Independent Peer Review Panel

IPRP Report No. 9, March 6, 2015

Comments on PG&E's Central Coastal California Seismic Imaging Project Report part 3: onshore seismic studies intended to reduce the uncertainty in seismic hazard at Diablo Canyon Power Plant

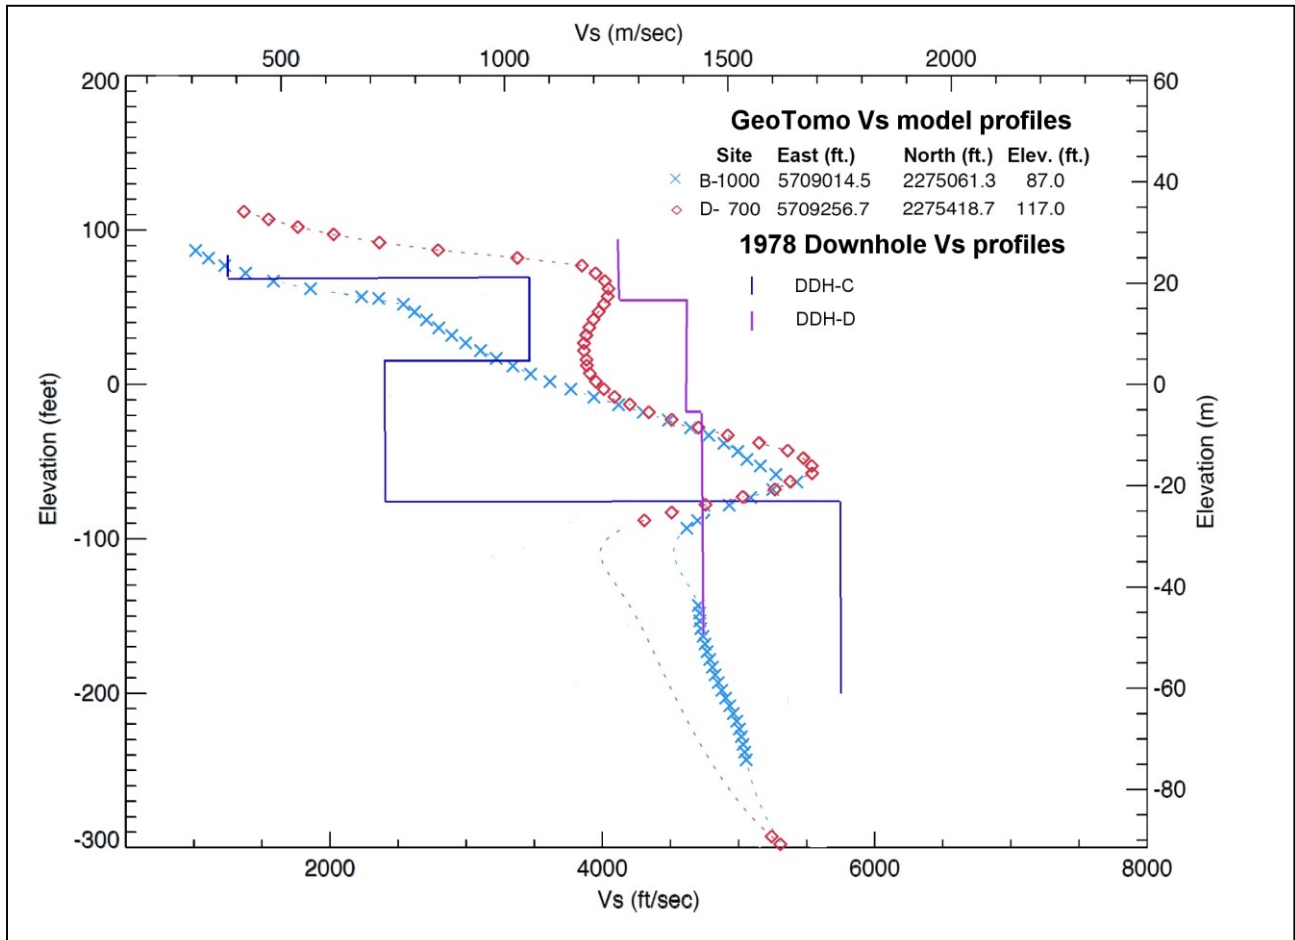
Comparison of V_s profiles from the tomographic model with profiles measured in 1978 shows broadly similar ranges of V_s and variation of V_s with depth. In detail, however, V_s profiles from the tomographic model do not appear to reproduce the variation in V_s with depth in nearby measured profiles. The most prominent feature in previous profiles is the high-velocity zone centered at approximately 50' elevation in profile DDH-C (Figure 1). The tomographic model includes a high-velocity zone near this elevation, but not in any of the profiles near the site of profile DDH-C presented on transects B-B' or D-D'. Below the high-velocity zone, profile DDH-C shows lower velocity (731 m/s) but all nearby profiles from the tomographic model show increasing velocity through this zone, reaching velocities of over 1600 m/s in the profile at 1000 ft on transect B-B' (the closest profile to DDH-C presented in the CCCSIP report). Downhole profile DDH-D shows much less variation of V_s with depth than the nearest profile shown in the CCCSIP report.

Differences between V_s profiles measured in 1978 and profiles derived from the tomographic model may reflect poor data or poor resolution in the 1978 profiles. If the 1978 downhole velocity surveys represent "ground truth", however, it appears that the tomographic model does not show some shallow high velocity layers up to 50' thick or low velocity layers up to 100' thick. The lack of correspondence between measured V_s profiles and V_s profiles estimated from the tomographic model suggests significant uncertainty remains in estimates of "site conditions" at DCP. The IPRP cannot

determine if these differences reflect poor data or analysis in one or both measurements of V_s or if both surveys are essentially correct, but have differing levels of spatial resolution. Certainly, the differences between V_s profiles from the tomographic model and previously measured V_s profiles should have been addressed in the CCCSIP report.

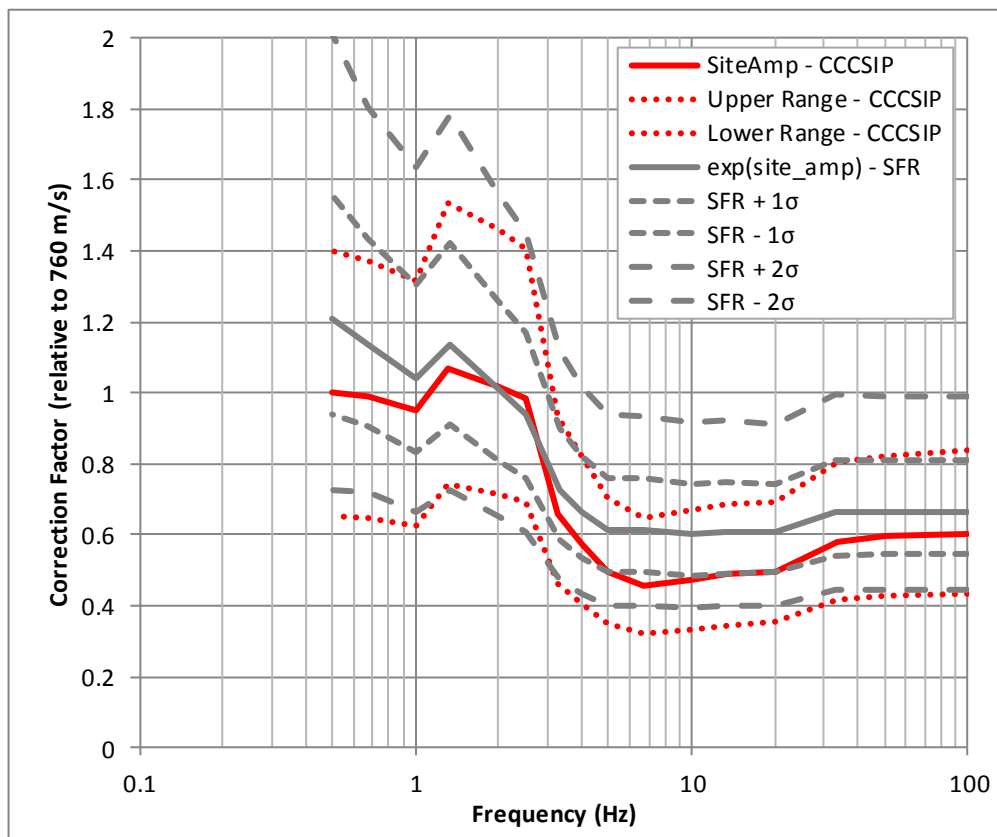
amplification factors for the foundation levels at the power block and the turbine building are listed in Table 3-3, Chapter 11 of the CCCSIP report. Figure 2 compares updated site amplification factors and associated uncertainties in the CCCSIP report with those used in the Shoreline Fault Report. In general, the new factors are slightly lower. However, given large uncertainty in site amplification, the difference should be considered insignificant.

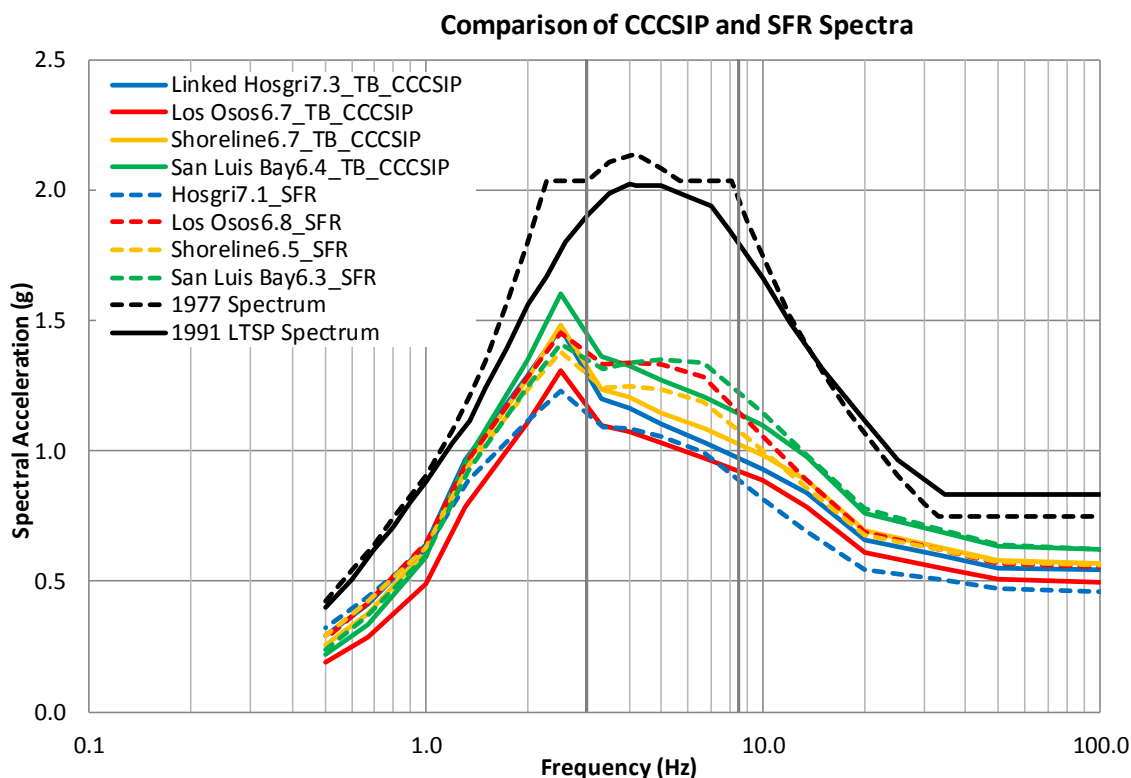
Figure 3 compares deterministic ground motion spectra presented in the CCCSIP report (for the turbine building foundation level, $V_{S30} = 980$ m/s, solid curves) and the Shoreline Fault Report (for the DCPD site with $V_{S30} = 1200$ m/s, dashed curves) for the four most important fault sources affecting the DCPD site. The PG&E 1991 LTSP/SSER 34, the 1977 HE (Hosgri Earthquake) design spectrum, and the frequency range important to DCPD structures (marked by vertical dark grey lines) are plotted for reference. Although the CCCSIP updates resulted in different ground motions for individual scenarios, there is little difference in estimated ground motion portrayed by the four scenarios as a group. Ground motion is higher for the linked Hosgri and San Simeon M7.3 scenario compared to the SFR Hosgri M7.1 scenario, except at frequency lower than 1 Hz. The updated Los Osos M6.7 scenario resulted in lower ground motions across the spectrum due to combined effects of the new GMPEs, slightly lower site amplification factors, and steeper minimum dip angle. For the Shoreline and San Luis Bay Fault scenarios, slightly lower ground motions were predicted by the CCCSIP updates for frequency range of 3 to 10 Hz. All scenario spectra fall below the 1991 LTSP and the 1977 HE design spectra. For each earthquake scenario, the CCCSIP deterministic spectrum for the power block foundation level ($V_{S30} = 1200$ m/s) is slightly lower than the CCCSIP spectra for the turbine building foundation level shown in Figure 3 due to higher V_{S30} value at the power block foundation level.

Figure 4. “Tornado Plot” ranking sensitivity of ground motion hazards to uncertainty in input parameters (presented by Norm Abrahamson at the January 8, 2015 IPRP public meeting).

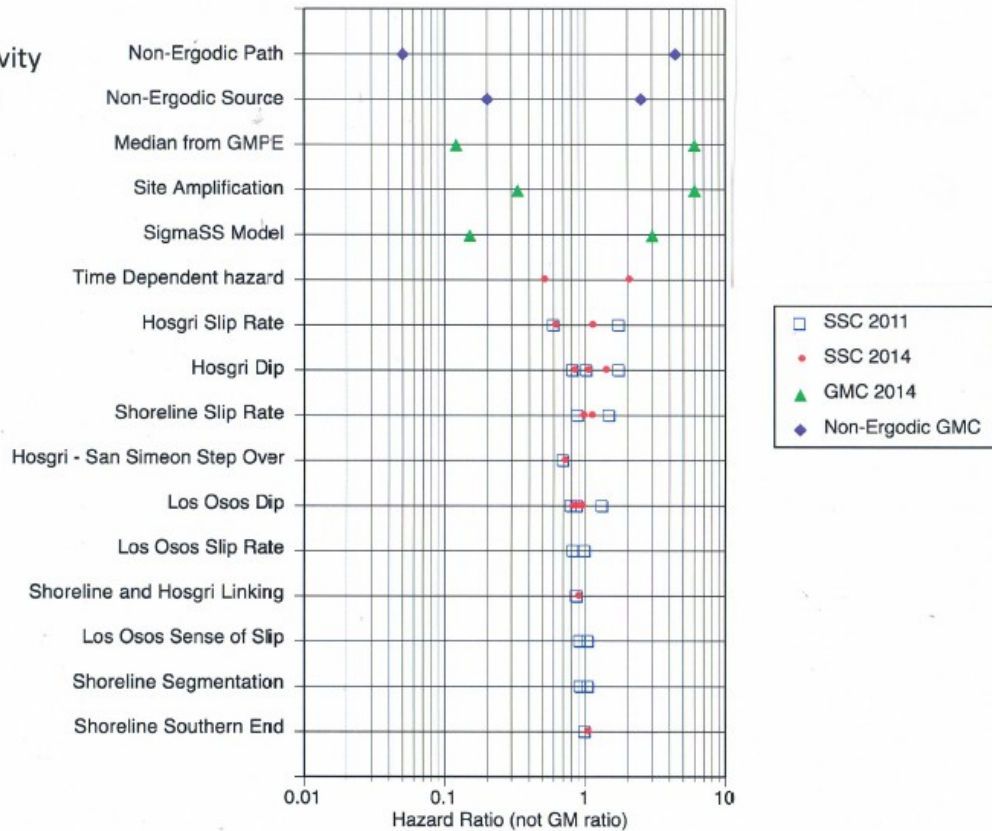
The updated tornado plot illustrates the reduction of uncertainties in some source parameters based on information developed by the AB1632 studies as reported in the CCCSIP. We note that uncertainty reductions shown in the updated tornado plot is based on PG&E's updated PSHA analyses as part of the SSHAC process. IPRP has not reviewed these new calculations and cannot comment on whether the reductions seen on the updated tornado plot are reasonable.

The most striking feature of this updated tornado plot is the 6 items related to ground motion calculation on the top of the tornado that have considerably greater uncertainty and hazard sensitivity compared to the source parameters (lower part of the tornado starting from Hosgri slip rate). The IPRP previously recognized the importance of ground motion calculation parameters (including site specific amplification and ground

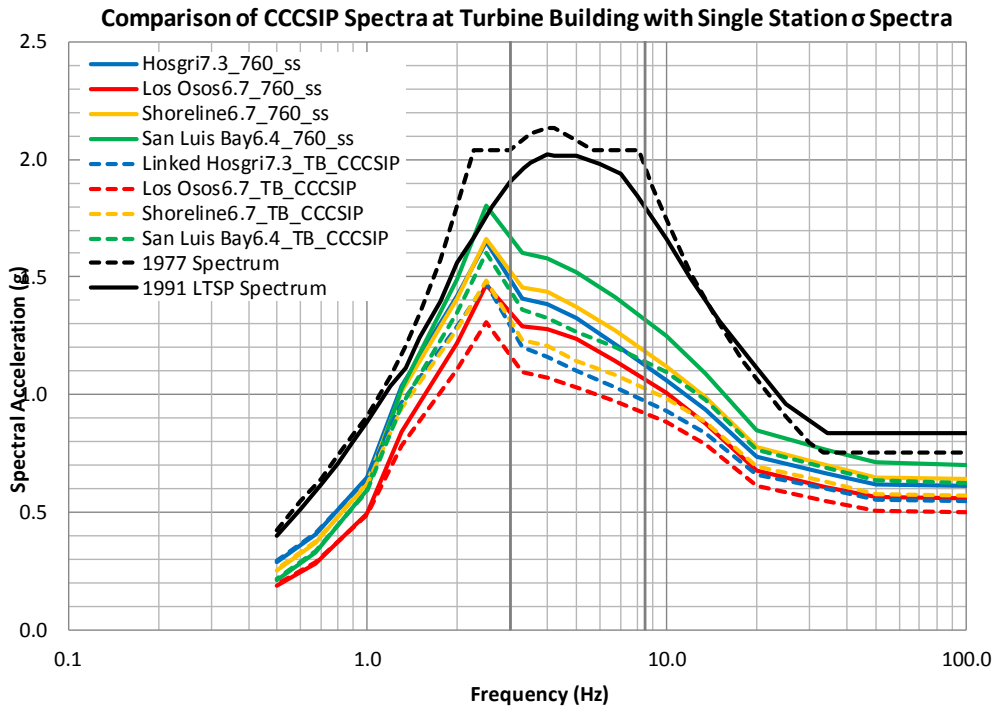
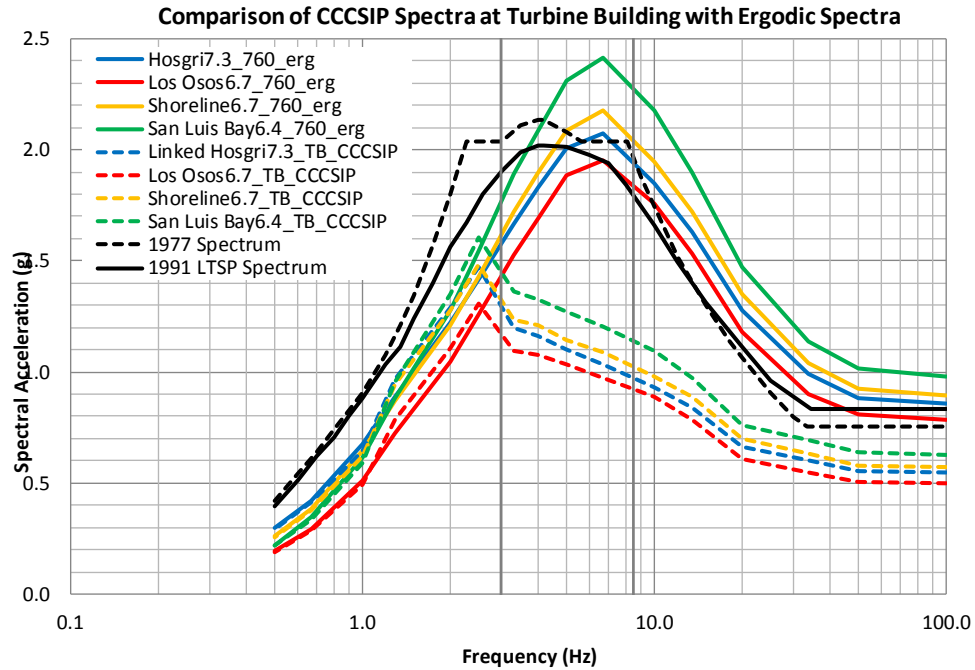
Figure 5 compares the CCCSIP deterministic spectra for the turbine building foundation (calculated using the single station sigma assumption, site-specific term, its uncertainty, and scaling from V_{S30} of 760 m/s to 980 m/s) with two sensitivity cases: (a) an average site with V_{S30} of 760 m/s using the ergodic assumption (i.e., 84th percentile ground motion calculated directly using GMPEs); and (b) a DCP site with V_{S30} of 760 m/s using the single station sigma assumption, the site-specific term and its uncertainty (i.e.,

Figure 5a shows that the deterministic spectra calculated based on the ergodic assumption exceed the 1977 HE and the 1991 LTSP spectra for all but one scenarios in the period range important to DCPD, which re-illustrates observations made in the IPRP Report No. 6 and depicted in Figure 7c of that report. Scaling of V_{S30} from 760 m/s to 980 m/s decreases deterministic ground motion across the spectrum, except for frequencies less than 1 Hz (Figure 5b). Differences between the V_{S30} of 760 m/s cases (solid curves) shown in Figures 5a and 5b reflect differences when ergodic assumption is used (Figure 5a) versus when single station sigma with site specific term is used (Figure 5b). For the DCPD site, the use of single station sigma with site-specific term appears to be the key factor that brings the deterministic spectra below the original design spectra.

While the single station sigma assumption and especially the site term have a significant effect on hazard, the site term is based on the observations of only two earthquakes. As described in IPRP Report No. 6, the IPRP is not convinced that the “site term” reflects some property of the site that would affect all earthquakes recorded at DCPD. The alternative hypothesis that additional factors related to the particular source or paths of those two earthquakes remains at least as plausible. The CCCSIP report does not include any additional studies to address this issue. The 3D site response analyses proposed by PG&E will not address whether single station sigma model is more reasonable than the ergodic assumption, nor will it reduce uncertainty in the site specific term that is calculated based on two recorded earthquakes. The proposed 3D site response model will address V_{S30} scaling and the effect of large variability in V_{S30} values at the DCPD site.

Figure 6. Comparison of deterministic ground motion spectra for the Shoreline Fault rupture linked with the Hosgri and San Simeon Faults.

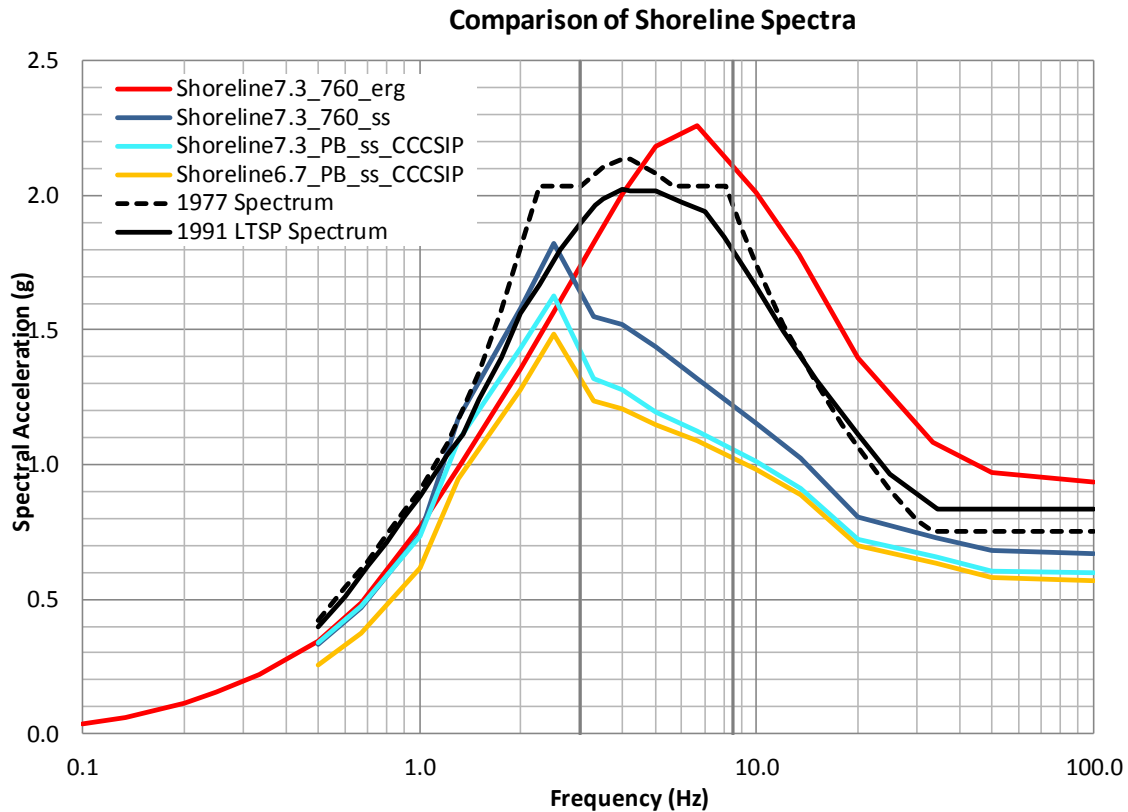
Figure 6 compares deterministic spectra for the CCCSIP sensitivity scenario assuming linked co-seismic rupture of the Shoreline, Hosgri, and San Simeon Faults (M7.3). It shows that deterministic ground motion increases across the spectrum as magnitude for the Shoreline Fault rupture increases from 6.7 to 7.3. This figure also shows increased ground motion as V_{S30} decreases from 1200 m/s [at the power block foundation level] to 760 m/s. More significantly, the figure shows, once again, that the most influential factor affecting deterministic ground motion estimates is the single station sigma assumption and the site term.
